MIL-L-6363/10
Amendment 1
3 September 1993

MILITARY SPECIFICATION SHEET

LAMPS, INCANDESCENT AIRCRAFT SERVICE, SINGLE CONTACT, BAYONET CANDELABRA BASE, G-5 BULB

EXAMPLE

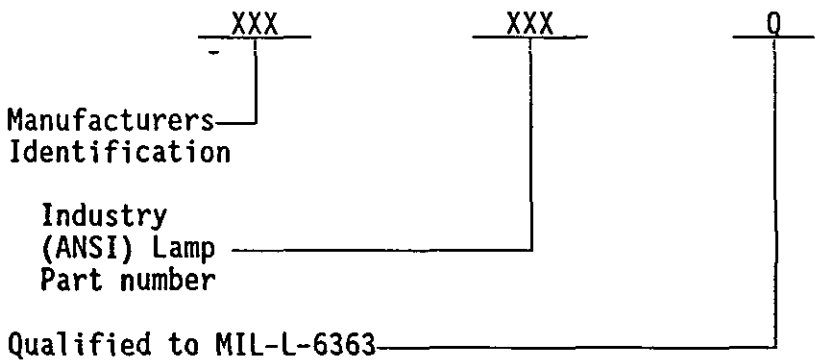
Requirement 11 Marking.

Delete - "To be determined for marking of production lamps," and rest of paragraph.

"11. Marking. Production lamps qualified to MIL-L-6363 and listed on QPL-6363 shall be marked in accordance with ANSI/NEMA C78.390 and as supplemented herein. ANSI/NEMA C78.390 authorized suffix letters shall be supplemented with the letter "Q" (MIL-L-6363 QPL item). The letter "Q" shall be incorporated into the method of designation in accordance with the following example:
